SUBJECT: TECHNICAL REVIEW OF ENVIRONMENTAL MONITORING AND
SITE-SPECIFIC DISTRIBUTION COEFFICIENT REPORTS

Docket No.: PROJ0734

TECHNICAL REVIEW OF ENVIRONMENTAL MONITORING REPORTS PREPARED BY DOE FOR TANK FARMS

Figure 1: FTF Monitoring Well Network. Adapted from Figure 4 in SRNS-RP-2014-00226.

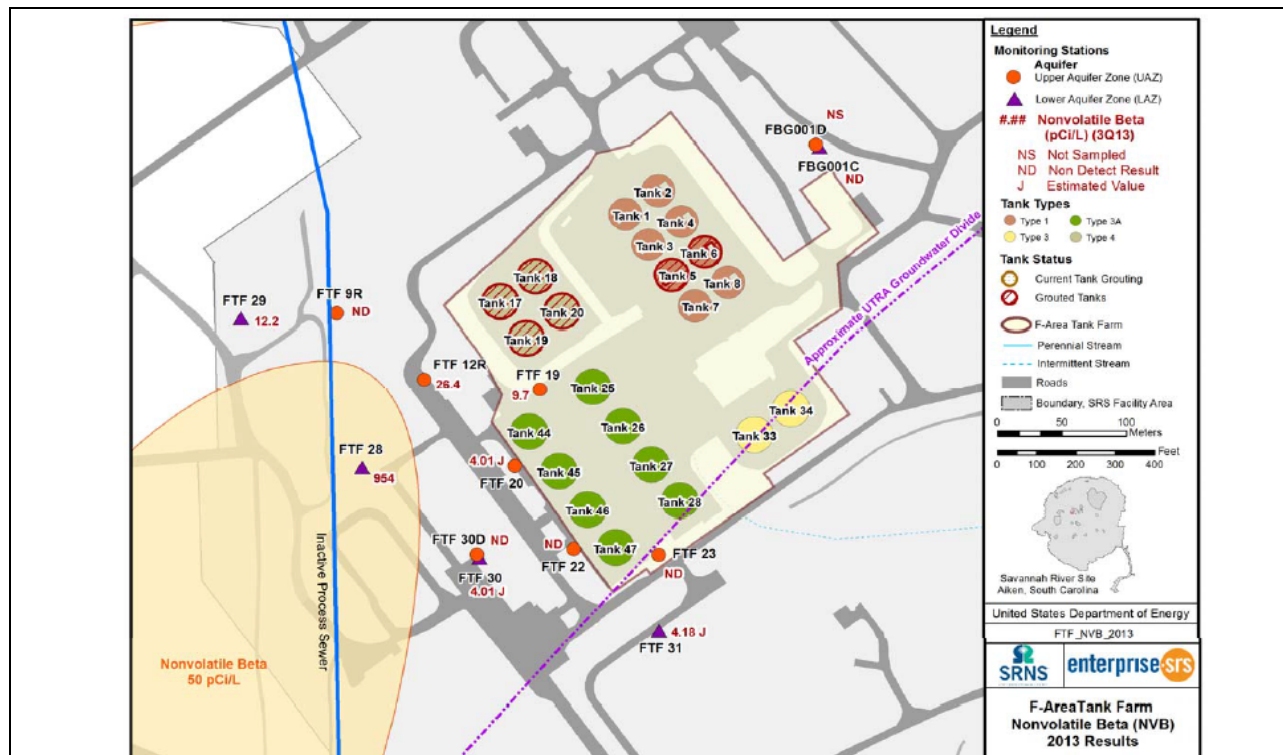
During 2013, SRS collected samples during the first and third quarters from 13² wells at the FTF (see Figure 1a). Constituents analyzed include gross alpha, nonvolatile beta, tritium, nitrate-nitrite, cadmium, chromium, manganese, sodium, and Technetium(Tc)-99. These constituents were selected based on historical monitoring and an evaluation of the most prevalent radionuclides expected during operations, waste removal, and tank closure activities. Radionuclide-specific analyses are performed if sample analysis results exceed trigger levels of 15 pCi/L gross alpha, or 50 pCi/L nonvolatile beta. In 2013, the nonvolatile beta trigger level was exceeded at a well screened in the lower aquifer zone of the Upper Three Runs Aquifer (UTRA), well FTF 28. Because well FTF 28 exceeded the screening trigger level, several other constituents were analyzed. Radium-226, Iodine-129, and Tc-99 were detected in the radionuclide-specific analyses. Consistent with measurements in previous years, Tc-99 was measured at values above 1000 pCi/L in well FTF 28 (see Figure 9 in SRNS-RP-2014-00226). Previously, Tank 8³ was implicated as a possible source of the non-volatile beta/Tc-99 measurements at well FTF-28 (SRNS-RP-2012-00022, Rev. 1). However, currently SRS scientists attribute the radioactivity measured at well FTF 28 to releases from the F-Area Inactive Process Sewer Line (FIPSL). The FIPSL is a vitrified clay pipe used to transfer acidic, low-level radioactive wastewater from the separations facilities to the F-Area seepage basins to the southwest of the FTF. A section of the FIPSL collapsed just south of well FTF 28 as shown

Figure 2: Western Groundwater Operable Unit Monitoring Well Network and Collapsed Section of F-Area Inactive Process Sewer Line (a) and Non-Volatile Beta Plume (b). Adapted from Figure A-2 and A-5 in ERD-EN-2005-0127 (2014).

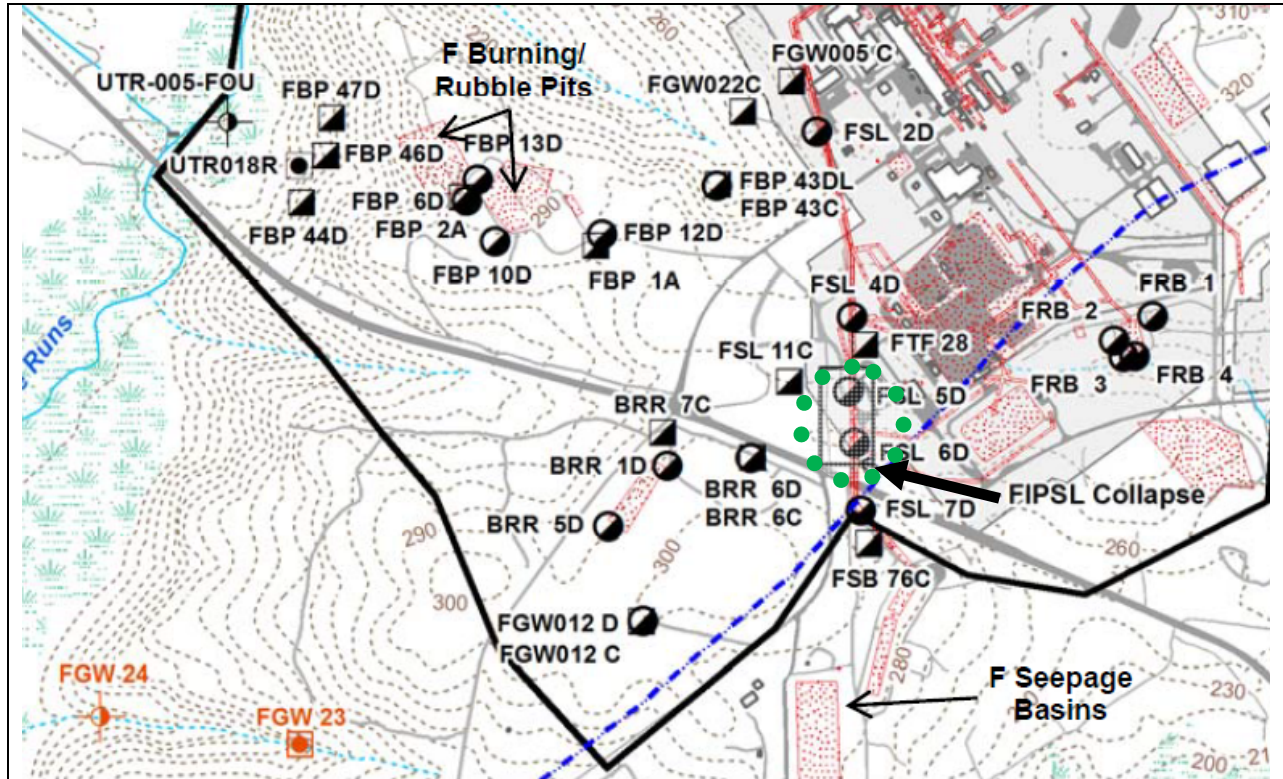
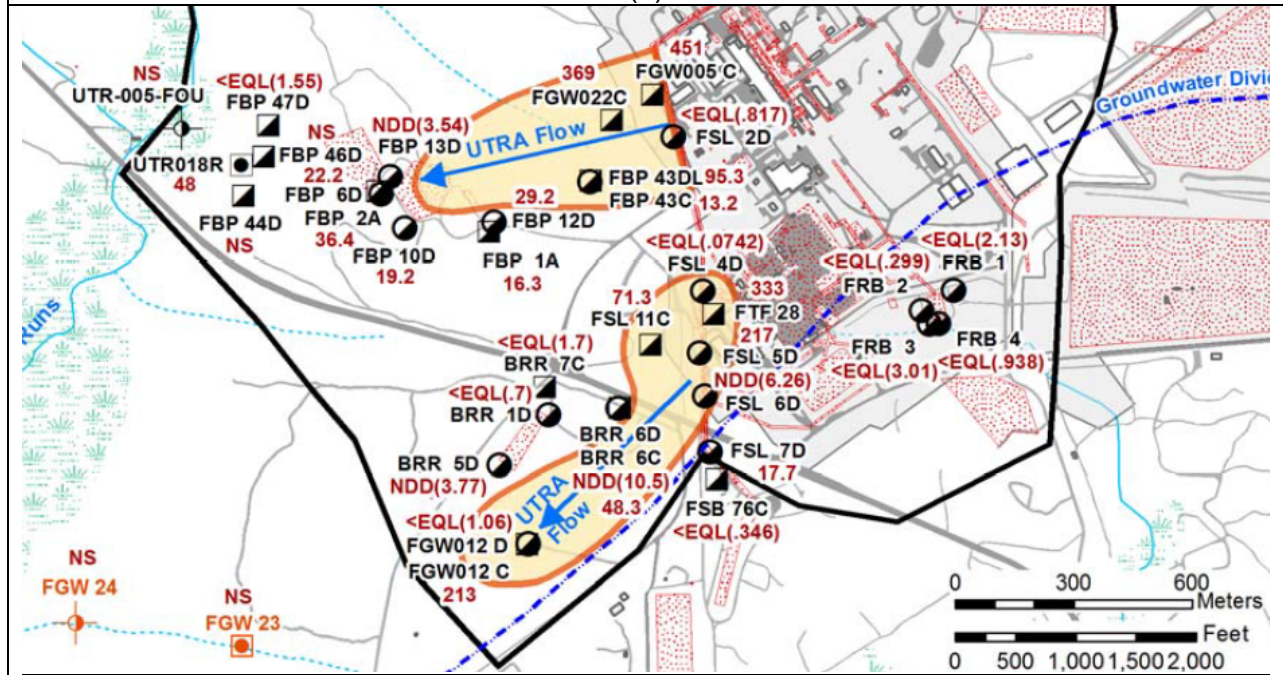
in Figure 2a. The FIPSL is associated with a non-volatile beta plume that extends from FTF 28 to monitoring wells located to the southwest of FTF-28 in the Western Groundwater Operable Unit (Figure 2b).

Near the collapsed section of the FIPSL, elevated non-volatile beta has been measured at wells FSL 5D (see Figure 2b), as well as FTF 28. However, FSL 5D is located in the upper aquifer zone of the Upper Three Runs Aquifer (UTRA) and is screened at an elevation of 204-224 ft, while FTF 28 is screened in the lower aquifer zone of the UTRA at an elevation of 151-161 ft (43 ft lower in the UTRA). Additionally, FTF 28 is also located slightly up-gradient and north of the collapsed FIPSL section. Although wastewater released from the FIPSL could have migrated towards FTF 28 in the vadose zone, it is more difficult to explain the vertical migration of the radioactivity to the lower aquifer zone of the UTRA where FTF 28 is screened in such a short lateral distance from the source. Elevated non-volatile beta has also been measured at FGW 12C, a well also screened in the lower zone of the UTRA at an elevation 154-164; however, this well is located approximately 700 m down-gradient of the FIPSL, a significant distance away from the source.

During the March 27-28, 2013, onsite observation NRC staff inquired about the source of elevated non-volatile beta and Tc-99 at FTF 28 (ML13113A322). DOE contractors indicated that the source of the FTF 28 non-volatile beta and Tc-99 was now thought to be the FIPSL, rather than Tank 8 as originally suspected. NRC staff inquired about the vertical extent of the plume that lies directly underneath the process sewer lines. DOE contractors explained that a residual hydrogen ion plume was also present that is similarly, vertically extensive in the UTRA further supporting the hypothesis that elevated non-volatile beta and Tc-99 at FTF was sourced by the FIPSL. SRNS-RP-2014-00226 also indicates that pH is depressed in FTF 28 (pH values between 4.5 and 5 in 2013) compared to other wells screened in the lower zone of the UTRA (see text on page 9 and Figure 10). However, SRNS-RP-2014-00226 also indicates that FTF 9R is likely impacted by the FIPSL with low pH increasing the solubility of manganese, while the pH measurements in FTF 9R were actually not low at all compared to background levels (5.9 and 6.3 in 2013). Given the small data set, and what appears to be a weak correlation between pH and constituent concentrations that have been attributed to the FIPSL, the arguments presented are not conclusive. Explanations for the vertical extent of the plume include the following: (1) the lower zone of the UTRA was contaminated during FTF 28 well construction, or (2) Tc-99 present in FTF 28 is impacted by another F-Area source (other than the FIPSL).

2. The NRC staff will continue to evaluate the source of elevated Tc-99 levels in well FTF 28. It is not clear that releases from the F-Area Inactive Process Sewer Line could migrate vertically to the lower zone of the Upper Three Runs Aquifer in such a short distance from the source. This evaluation is important to ensure that the hydrogeological system at FTF is well understood and that releases from the tanks could be detected by the monitoring well network. DOE could provide additional support for the source of contamination detected at well FTF 28 by performing particle tracking to better understand contaminant plume trajectories. DOE could also perform a more formal statistical analysis of FTF, and Western Groundwater Operable Unit well data to correlate contaminant concentrations associated with various sources.

Figure 3: Stream Traces from FTF Tanks, FTF Local Model Grid, and FTF Well Locations Assigned to Model Cells. Adapted from Figure 5.2-5, SRS-REG-2007-00002, Rev. 1.

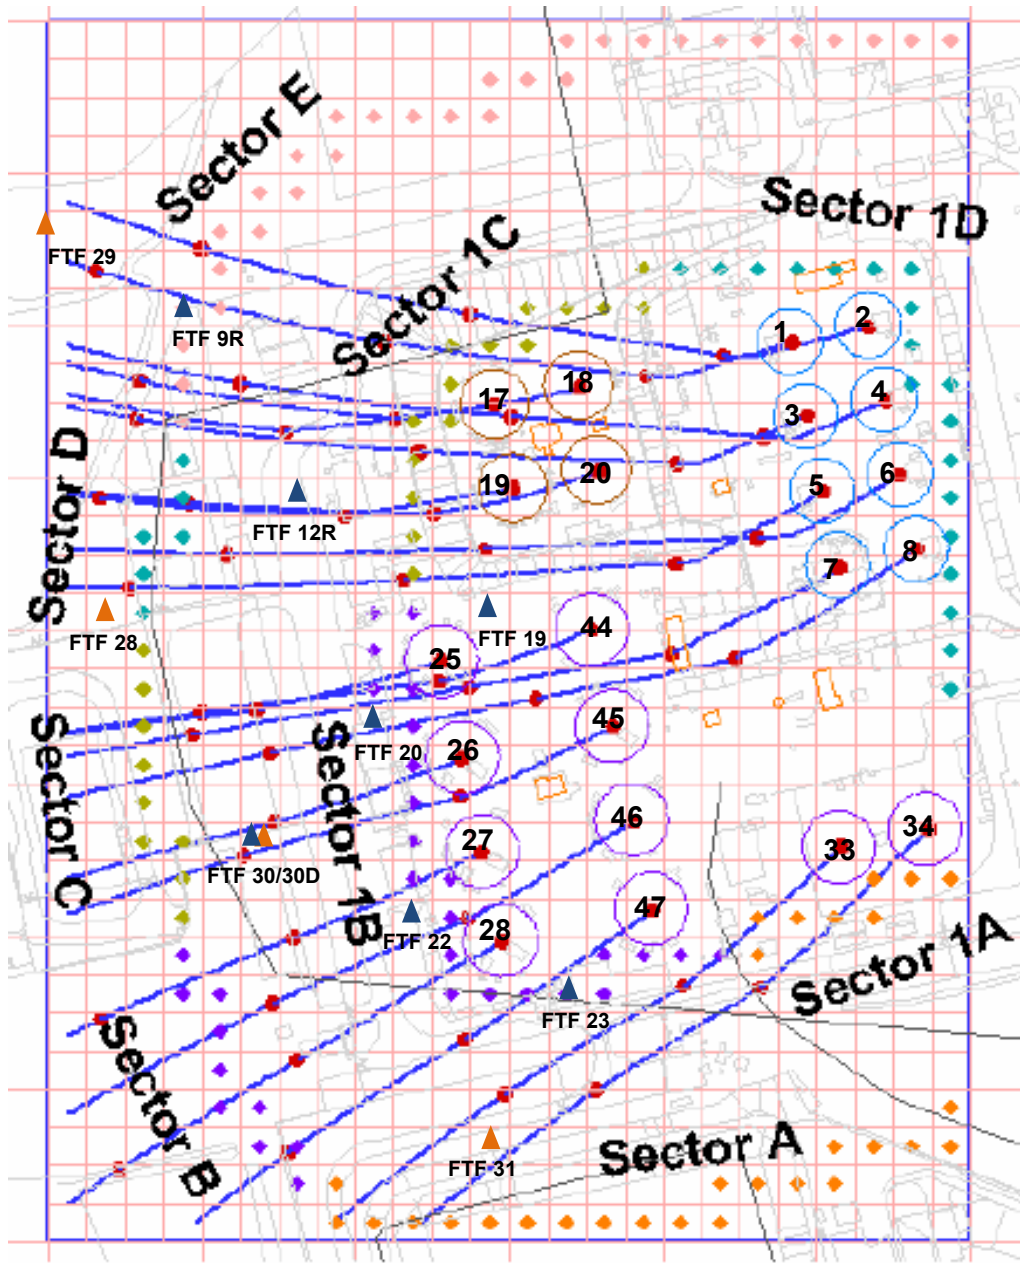
In an effort to evaluate the efficacy of the FTF monitoring well network for detecting future releases of radioactivity from the tank farm, NRC staff analyzed DOE's FTF Performance Assessment (SRS-REG-2007-00002, Rev. 1) calculations (e.g., Figure 3) and ran DOE's saturated zone PORFLOW models. NRC staff matched features with known coordinates on (1) a map that utilized the Universal Transverse Mercator (UTM) coordinate system to (2) the maps illustrated on Figures 5.2-2 and 5.2-5 in SRS-REG-2007-00002, Rev. 1, that depict the FTF local model grid, which is not in the UTM coordinate system. This was necessary because only UTM coordinates were available for FTF wells (see SRNS-RP-2014-00226, Table 1), and the UTM coordinates had to be translated to FTF grid cells. Next, FTF PORFLOW model simulations of Tc-99 releases from various FTF sources were executed, and concentrations were extracted from the model from the water table surface, vertically downward to the bottom of the model domain at each FTF well location. Tc-99 was chosen for the simulations because it is fairly mobile and long-lived (i.e., acts like a conservative tracer that would produce a fully developed plume in shorter simulation periods). The statistical analysis of concentrations in the

Based on NRC staff's evaluation, NRC staff thinks that the monitoring well network could be enhanced to help ensure releases from the FTF facility are detected. Table 1 lists each FTF well and provides an assessment of the tank or set of tanks that each FTF well is best aligned with based on Figure 3 stream traces, and also evaluates, based on the PORFLOW model simulations described above, whether the well is screened at an appropriate depth in the aquifer to best detect releases from those tanks. While the PORFLOW calculations reflect modeling results and may not reflect reality, it is not clear to NRC staff how DOE contractors selected the monitoring well locations at FTF, as they do not always appear to be screened at the most appropriate depth based on FTF Performance Assessment (PORFLOW) modeling results. NRC staff suggests that when the monitoring well network is evaluated in the future, DOE contractors perform an evaluation using the FTF Performance Assessment (PORFLOW) model and provide input on the horizontal and vertical distribution of wells in the FTF monitoring network to DOE subcontractors responsible for well construction, maintenance, and monitoring. This effort should be focused on identifying well locations that would maximize the ability to detect FTF releases and minimize false negative monitoring well results. Adequate groundwater monitoring data could help validate Performance Assessment Models, as well as provide direct evidence that the tank farm facilities are operating as intended. NRC staff will continue to monitor the basis for and adequacy of the FTF monitoring well network and field and chemical data collected, as tank farm closure progresses.

1. The NRC staff will continue to monitor the ability of the tank farm monitoring well network to detect releases from the tank farm facilities following closure. DOE could evaluate the monitoring well network by performing an analysis of the centerline of plumes emanating from tank sources should releases occur in the future, and provide input on optimal well locations to ensure that future releases from the tank farm facility would be detected.
